CITY PLANNING COMMISSION

- APPLICATION:
1. Environmental Determination
  2. Amend 1974 General Plan from Hospital to Residential for 15± acres
  3. Amend 1968 Valley Hi Community Plan from Hospital to Medium Density Residential for 15± acres
  4. Rezone 6± acres from Single Family (R-1) to Garden Apartment-Review (R-2B-R) zone
  5. Plan Review for 332 unit apartment complex

PROPOSAL: 332 unit apartment complex

APPLC. NO. P83-143

EXHIBIT A

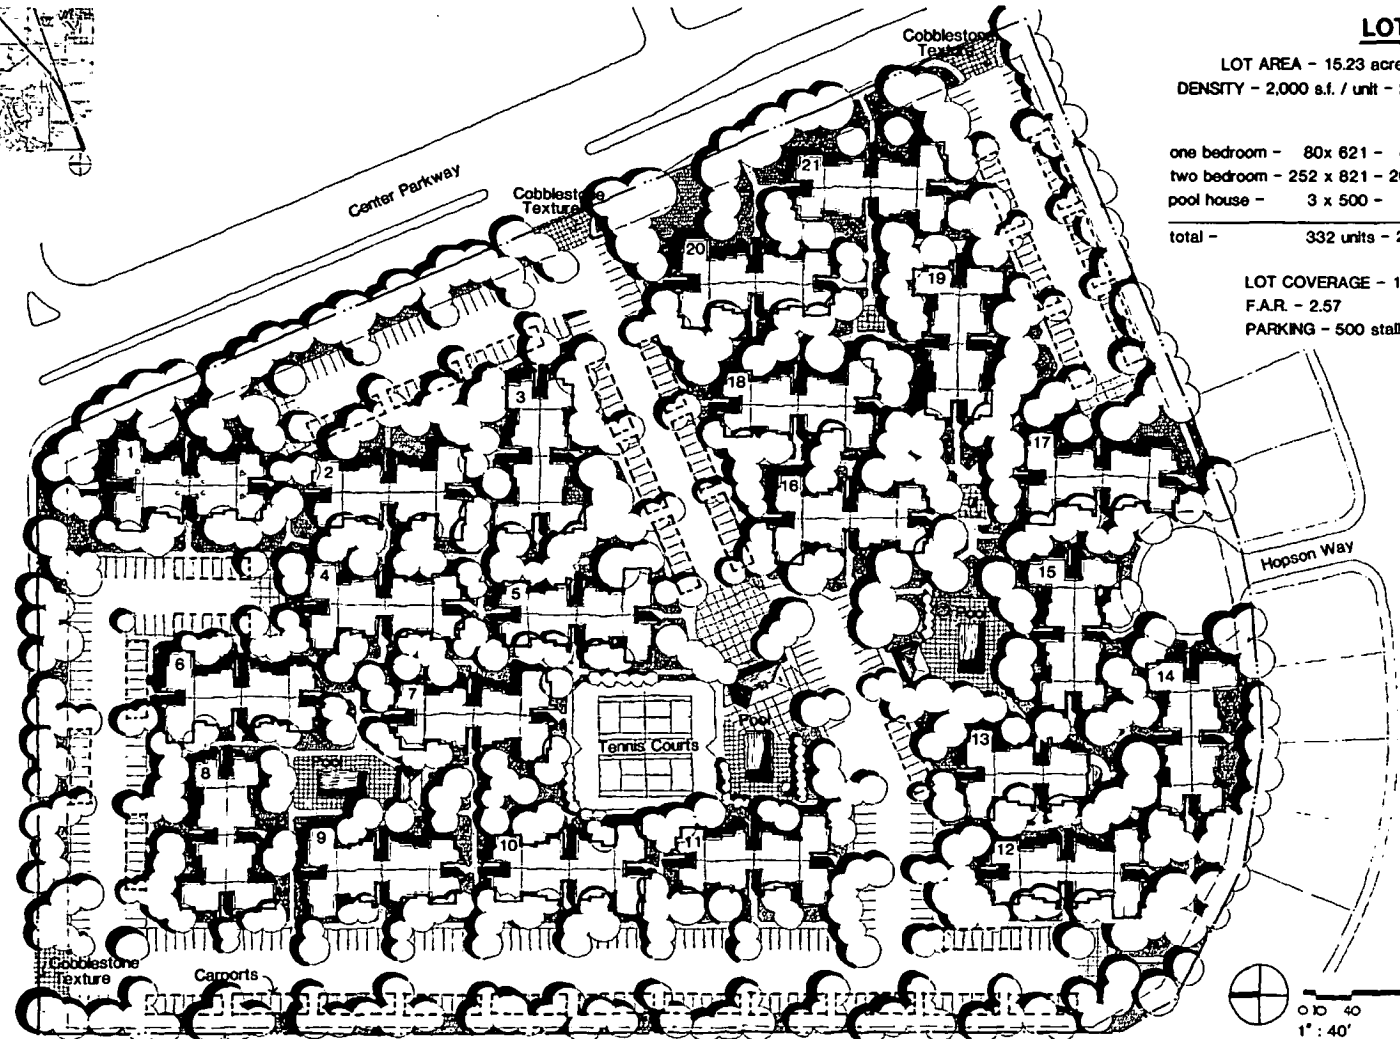
1. The project has frontage onto major streets (Mack Road and Center Parkway), affording the level of access that is essential for multiple family development.
2. The project plans originally provided for frontage around a proposed cul-de-sac ending off Hopson Way (see Exhibit A). However, the plans have been revised and the existing stub street is now proposed for abandonment, with the right-of-way reverting to the adjacent corner lots. As part of the abandonment staff proposes that the applicant be required to remove existing street improvements on Hopson Way and provide curb, gutter and sidewalk on the north side of Bamford Drive. The right-of-way of Hopson Way should be filled and graded to provide proper surface drainage to Bamford Drive.

The proposal for abandonment stemmed from staff's concern that access through Hopspon Way might result in problems for the single family neighborhood, in terms of apartment related traffic and pedestrian movement through to Bamford Drive.

- a. The applicant shall abandon Hopson Way with reversion to adjacent corner lots. Applicant shall remove curbs, gutters, sidewalks and street paving from Hopson Way and provide curb, gutter and sidewalk for the north side of Bamford Drive.

**EXHIBIT**

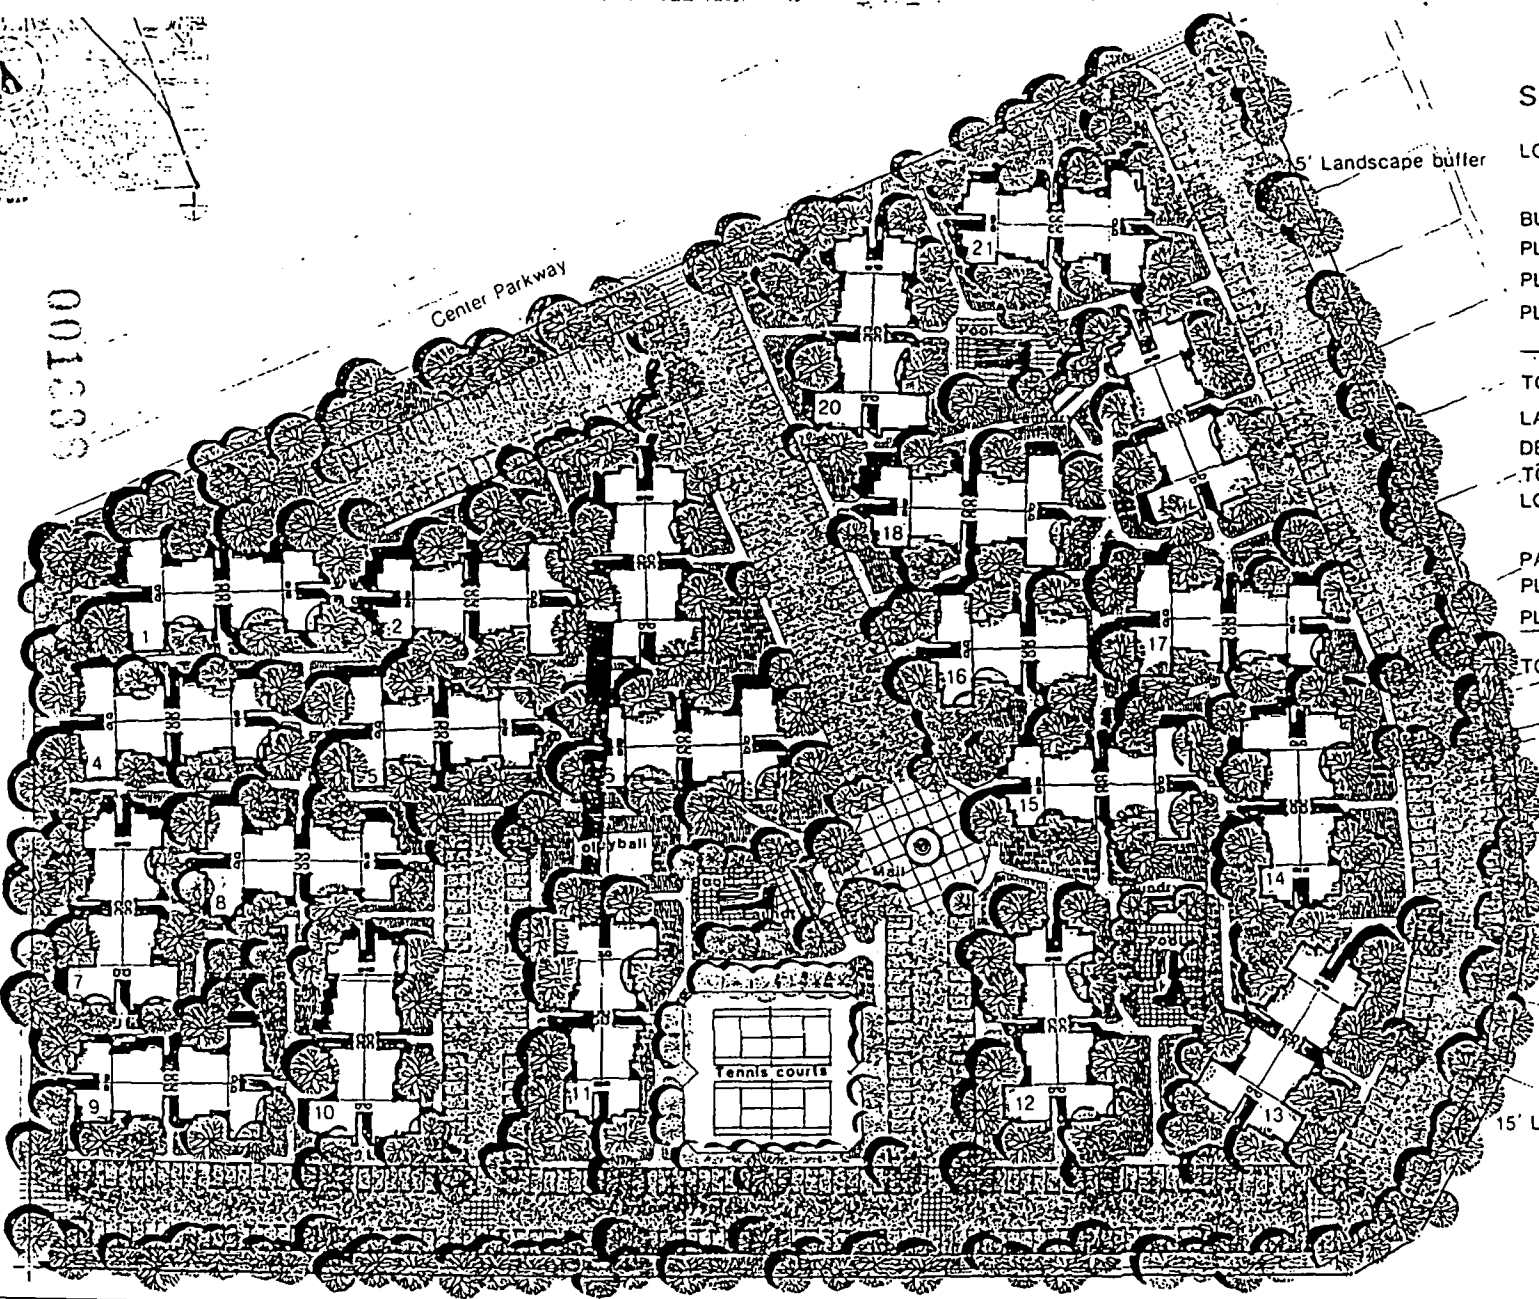
3. Staff is of the opinion that whenever possible a six foot masonry wall should be required on the perimeter of multiple family development when abutting single family neighborhoods. Although existing wood fencing is located at the rear of most of the abutting single family lots to the south, a masonry wall would provide a more durable low maintenance fence and uniformity of fencing material as viewed by apartment tenants, and afford a degree of sound attenuation.

To minimize the impact of construction noise on single family residences on Bamford Drive, staff believes that the suggested six foot wall should be constructed when the southerly six± acres are being developed. Prior to issuance of any building permits for this six± acre area the wall should be installed.

4. The project is designed so that there will be no less than 100 feet between any apartment structure and any single family lot. Along with the factor of distance and the six foot masonry wall, intense landscaping within a 15 foot landscape buffer will afford visual privacy to single family residents. Staff suggests evergreen trees with overlapping spread to assure a year-round screen of landscaping.

5. Due to long lines of sight from the public streets down the driveways, additional tree planters need to be located in place of some parking stalls. These trees will visually relieve the perceived length of the private drives.
6. Regional Transit indicates that a bus stop will be located on the Center Parkway frontage for service beginning in September.
7. The Traffic Engineering Division is concerned that ingress and egress to the first several parking spaces at the Mack Road entrance may at times cause queing back onto Mack Road. Such an occurrence could be quite hazardous, especially during periods of heavy traffic, justifying elimination of the first several spaces.
8. Details such as trash enclosures have not been provided. It would be appropriate that general compliance with the attached Multiple Family Residential Design Criteria be required (see Exhibit D).

- b. A six foot high masonry wall shall be located on the property line abutting R-1 (Single Family) zoned property. The portion of the wall abutting existing single family residences shall be constructed prior to issuance of building permits for the buildings located on the southerly six± acres of the subject site.

- c. The first four spaces at the Mack Road entrance shall be eliminated and landscaped.
- \*\* d. Landscape and irrigation plans/shall be submitted for review and approval of the staff prior to issuance of building permits. The 15 foot landscape buffer where it abuts existing single family shall be in place prior to occupancy of any buildings in the southerly six± acre portion of the project. Additional tree planters shall be located along drives to foreshorten the line of sight from public streets down the long drives.  
*to include a child's play area,*

- e. The applicant shall cooperate with Regional Transit in determining a location for a bus stop.
- f. A revised site plan indicating the above condition shall be submitted to staff prior to issuance of building permits.
- g. The development plans shall be in general conformance with the Multiple Family Residential Design Criteria (Exhibit D).
